TITLE: Sheet_1		REV: 1.0
	Company: Your Company	Sheet: 1/1
	Date: 2023-10-05 Drawn By: Denjhang

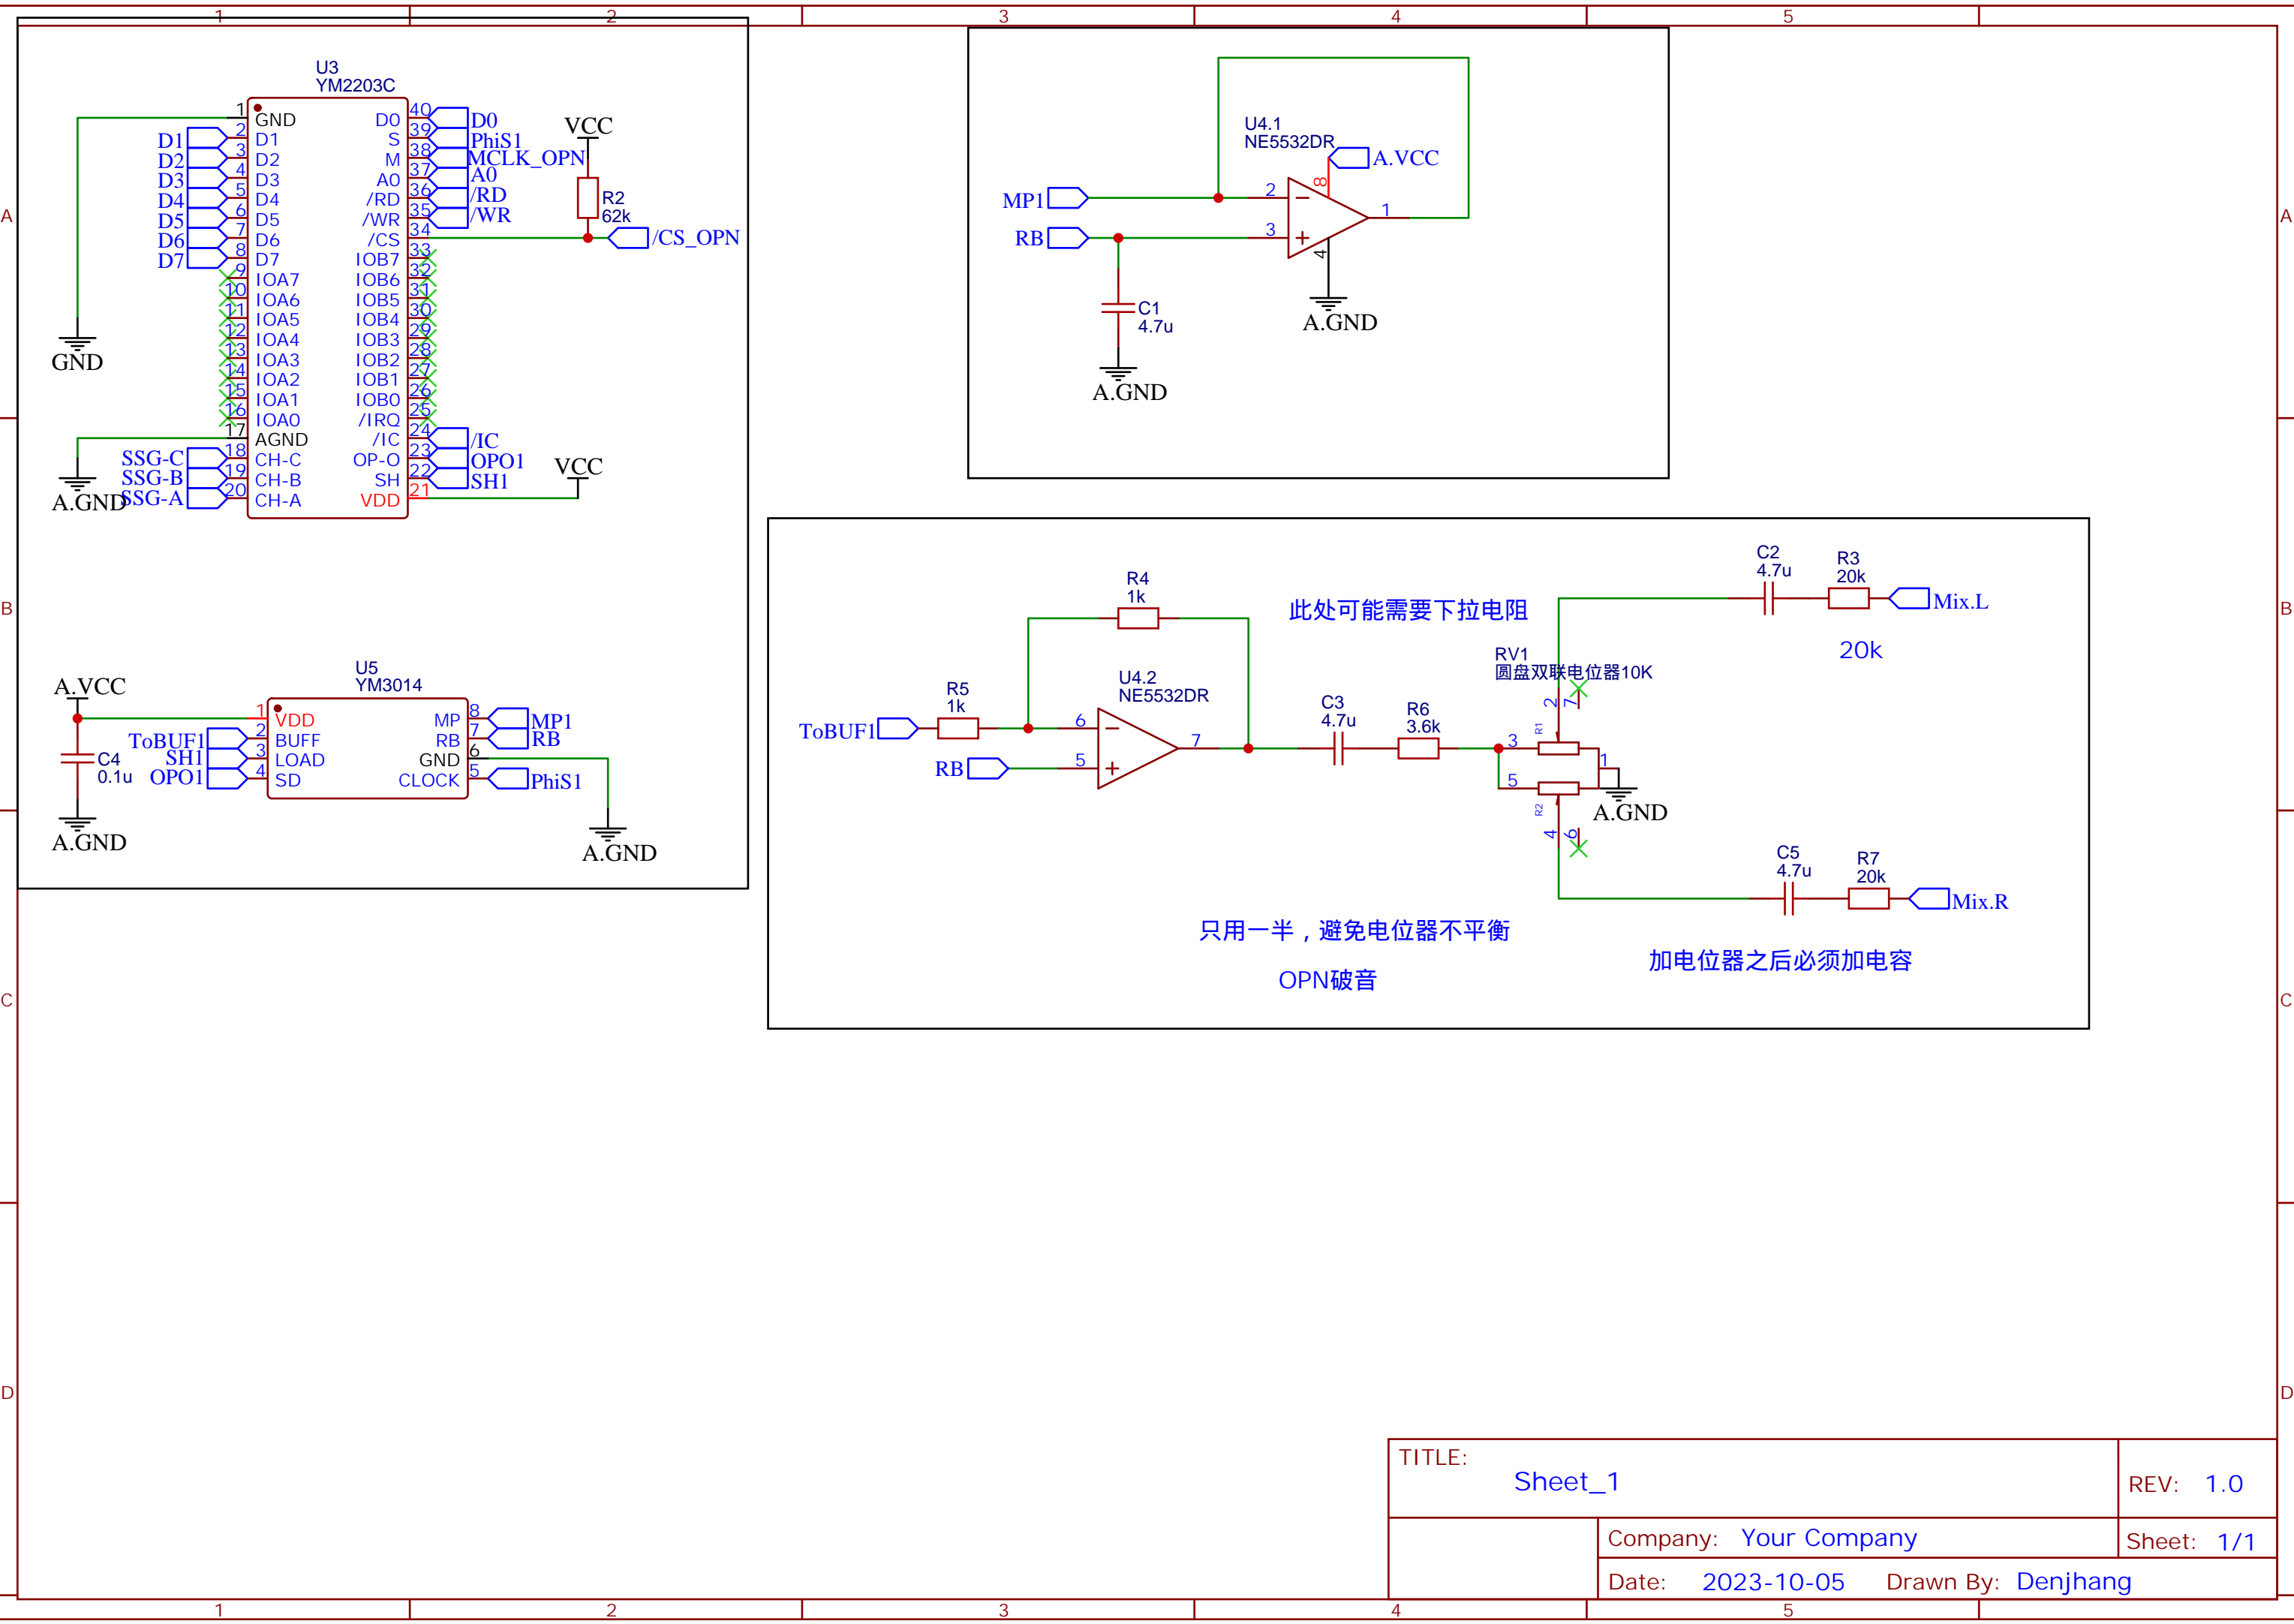
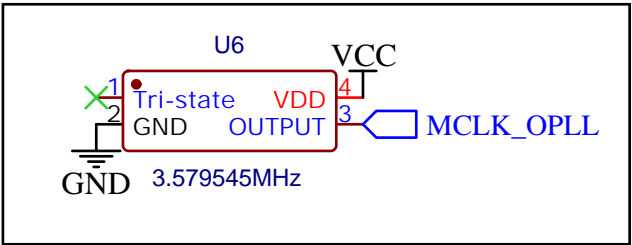
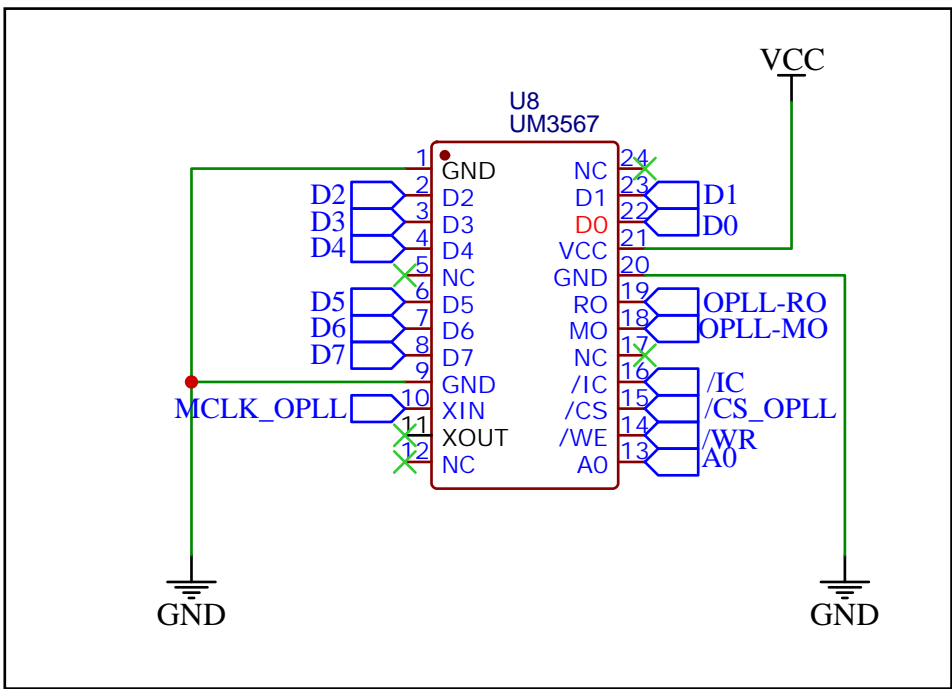
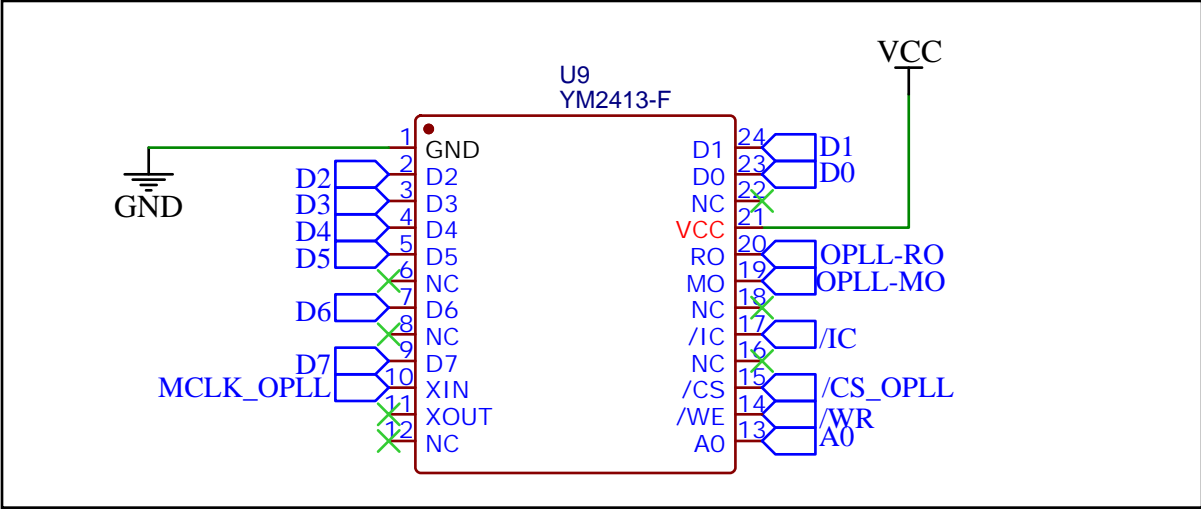
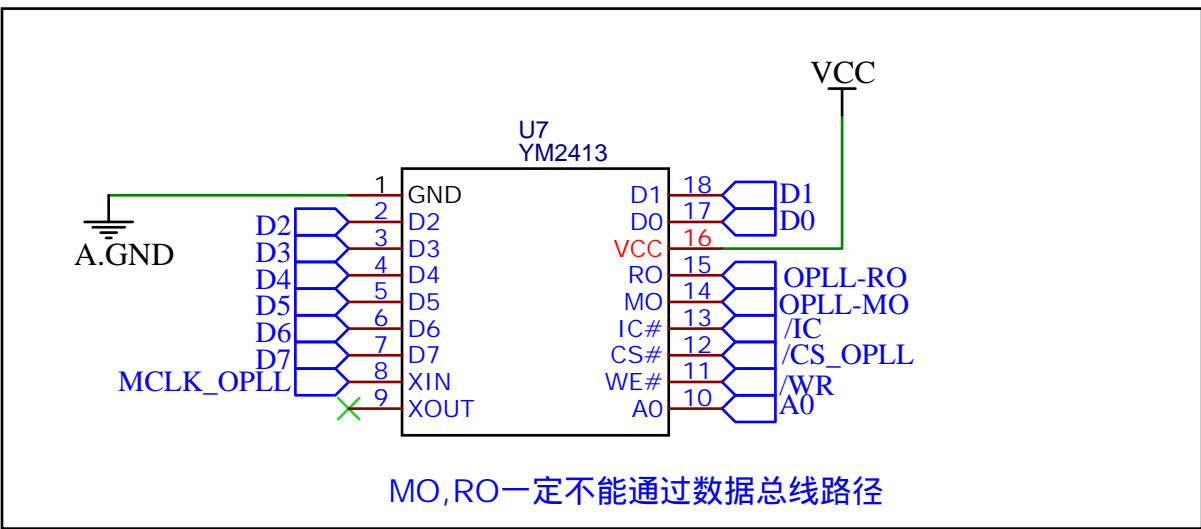
低音增强电容，未验证

TITLE: Sheet_1		REV: 1.0
	Company: Your Company	Sheet: 1/1
	Date: 2023-10-05	Drawn By: Denjhang

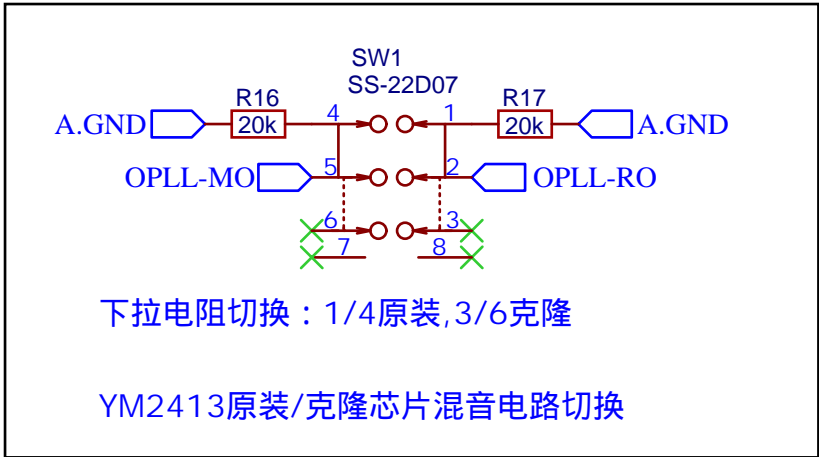
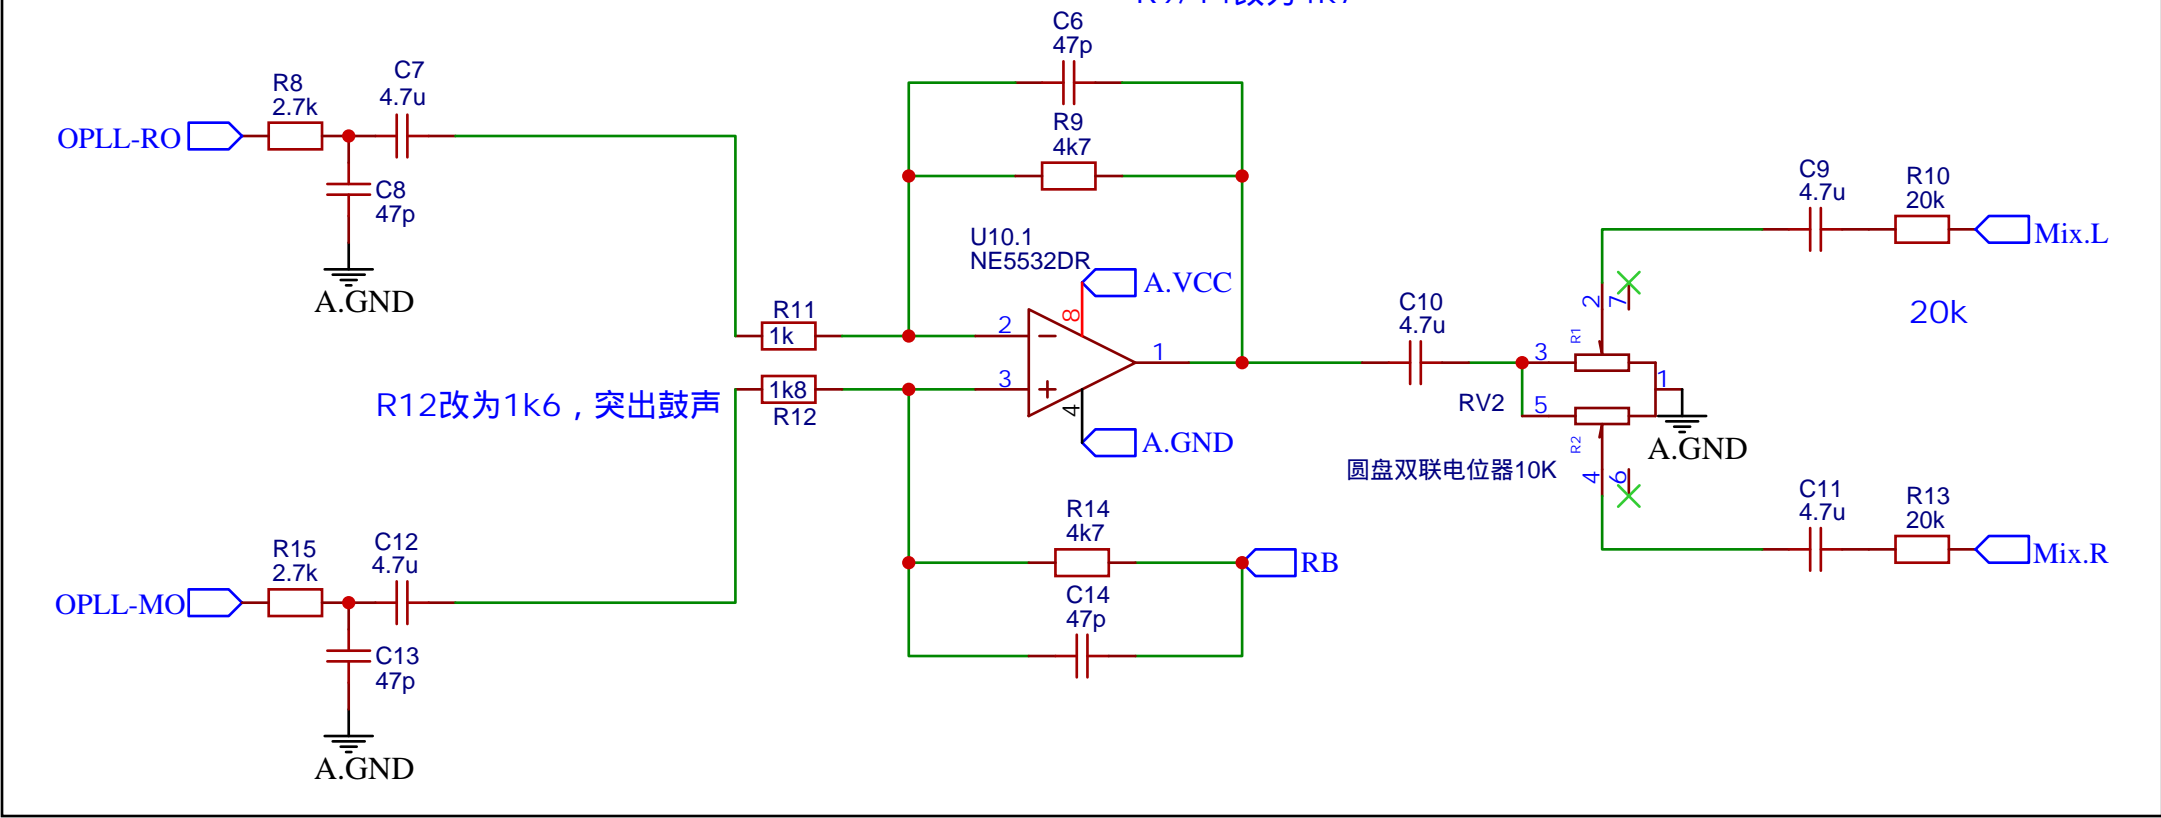
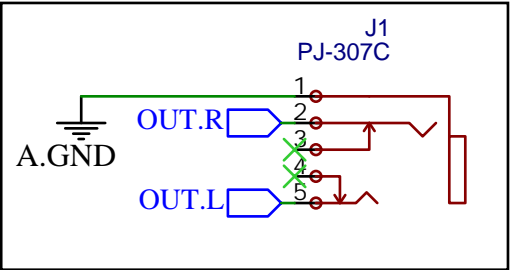
R9/14改为4k7
